ENTRANCE DOOR LIGHT

Prevost vehicles

DESCRIPTION

On the vehicles affected by this bulletin, install a light at the entrance door. This bulletin describes how to install the new entrance door upper molding and the light with its wiring.

Figure 3

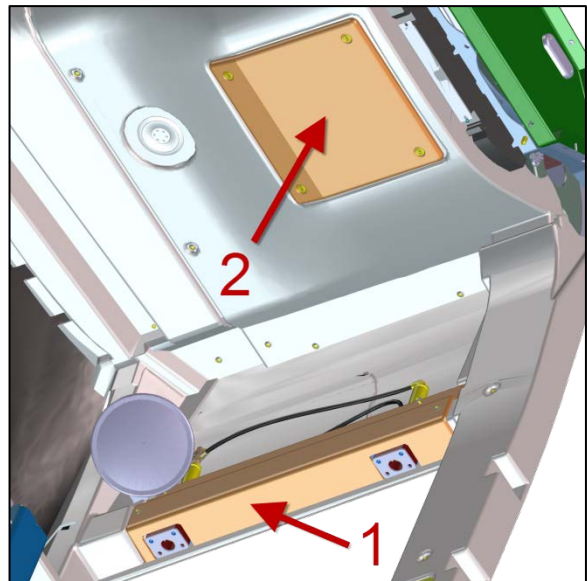
3. Remove entrance door upper moulding (item 1, Figure 3). This part will be replaced by the new moulding #3210118. Keep screws for the installation of the new moulding.
4. Remove front RH roof access panel (item 2, Figure 3).

Figure 4

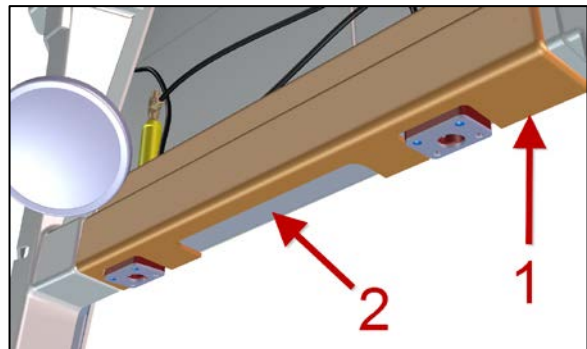
5. Install the new entrance door upper moulding #3210118 (item 1, Figure 4). Do not install screws yet.
6. On the vehicle metal structure, mark up the shape of the moulding cut out (item 2, Figure 4).

Figure 6

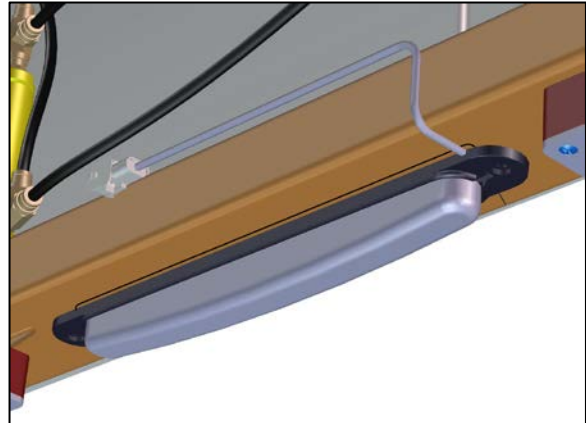
8. Center the entrance door light (Figure 6) with the marks made in step 41.
9. Mark the position of the holes to be drill through the metal structure (Figure 6). These holes will be used to support the light with screws.
10. Drill two holes $\text{Ø}9/64'' \pm 1/64''$ through the vehicle metal structure.

Figure 7

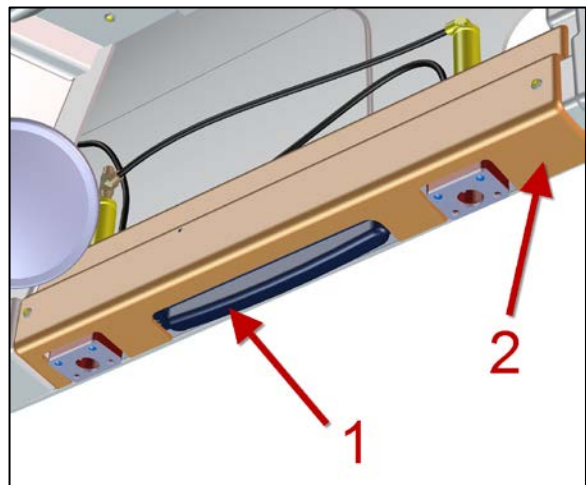
11. Install light #830008 with two screws #500854 (item 1, Figure 7).
12. Install new entrance door upper moulding #3210118 (item 2, Figure 7).

Figure 12

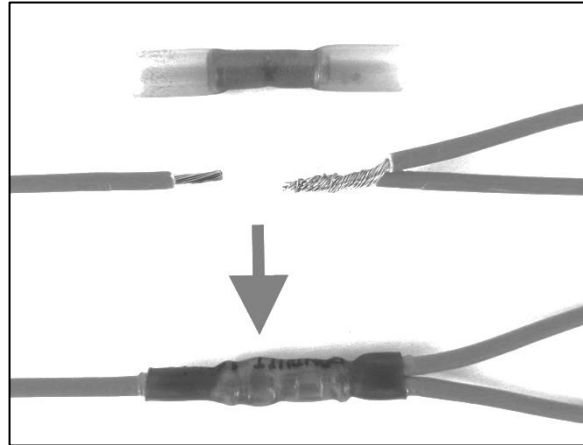
17. Connect wire 35 of the existing L17 light with the wire 35 of the new L15 light. Splice the wires as shown in the Figure 12.
18. Connect wire 86ARtn of the existing L17 light with the wire 86ARtn of the new L15 light. Splice the wires as shown in the Figure 12.
19. Using the heat gun, fully heat shrink the tube until no more shrinkage is apparent.
20. Check if the new light is working.
21. Tape the wires to the insulation on the side and to the upper side of the ceiling trim to prevent noise. Use hockey tape.

Figure 20

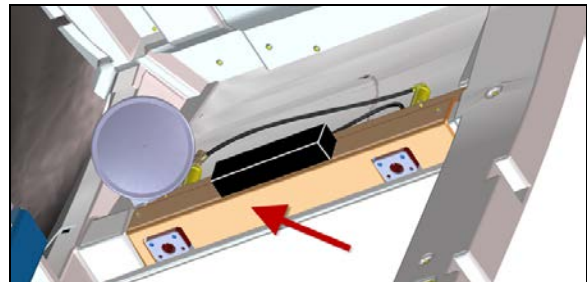
34. Remove entrance door upper moulding (Figure 20). This part will be replaced by the new moulding #3210118. Keep screws for the installation of the new moulding.

Figure 25

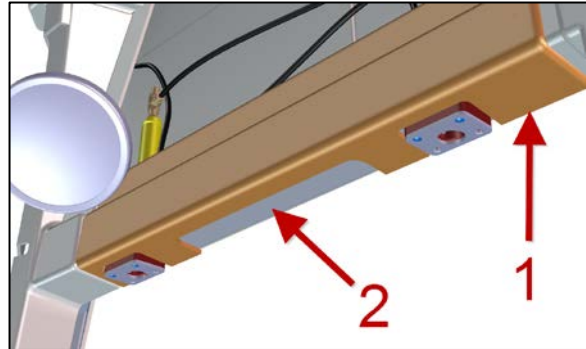
40. Install the new entrance door upper moulding #3210118 with the screws (2) (item 1, Figure 31).
41. On the vehicle metal structure, mark up the shape of the moulding cut out (item 2, Figure 25).

Figure 26

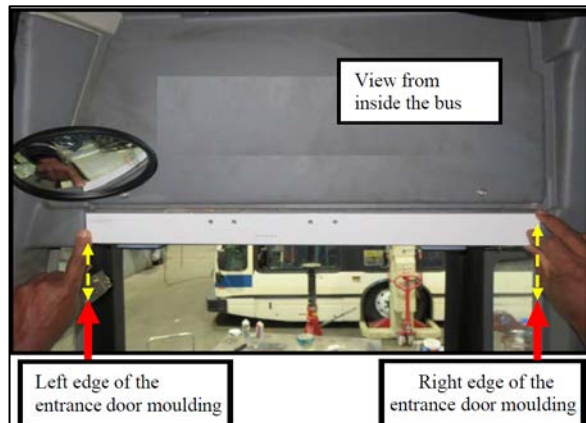
42. Align the drilling template (TA # 96-91-9451) with the new entrance door moulding and using a punch tool mark up the four drilling points (center points) (Figure 26).

Figure 28

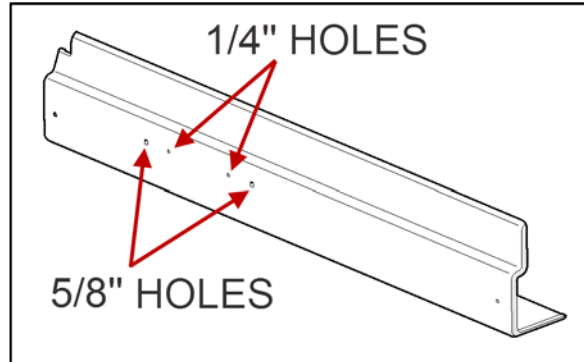
44. Drill two holes $\varnothing 1/4"$ and two holes $\varnothing 5/8"$ (Figure 28).

Figure 29

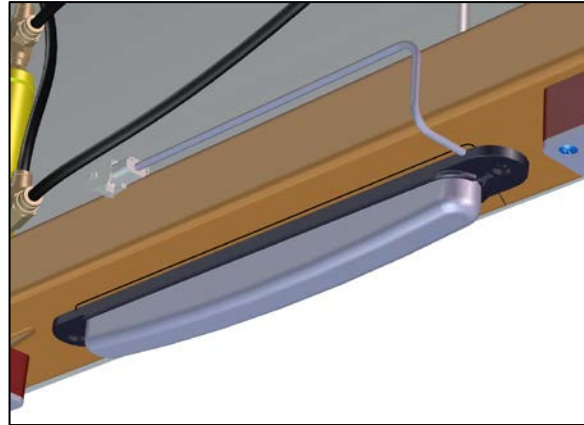
45. Center the entrance door light (Figure 29) with the mark made in step 41.
46. Mark the position of the holes to be drill through the metal structure (Figure 29). These holes will be used to support the light with screws.
47. Drill two holes $\varnothing 9/64"$ $\pm 1/64"$ through the vehicle metal structure.
48. Install light #830008 with two screws #500854 (item 1, Figure 29).

Figure 31

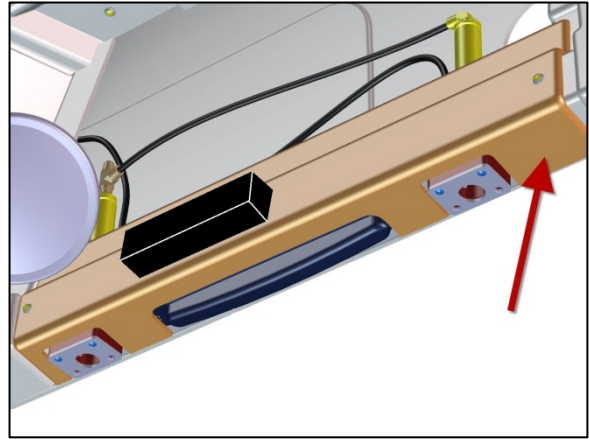
51. Install new entrance door upper moulding #3210118 (item 2, Figure 31).

Figure 36

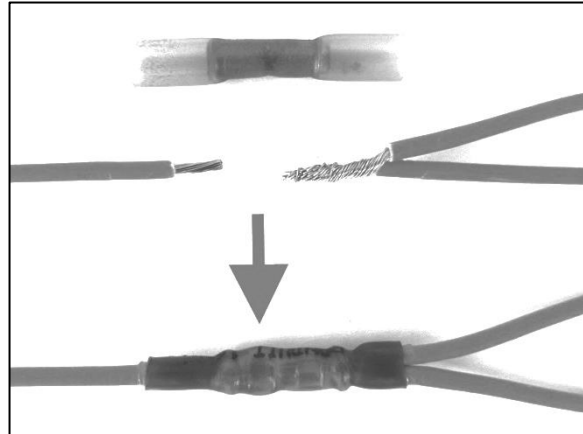
56. Connect wire 35 of the existing L17 light with the wire 35 of the new L15 light. Splice the wires as shown in the Figure 36.
57. Connect wire 86ARtn of the existing L17 light with the wire 86ARtn of the new L15 light. Splice the wires as shown in the Figure 36.
58. Using the heat gun, fully heat shrink the tube until no more shrinkage is apparent.
59. Check if the new light is working.
60. Tape the wires to the insulation on the side and to the upper side of the ceiling trim to prevent noise. Use hockey tape.
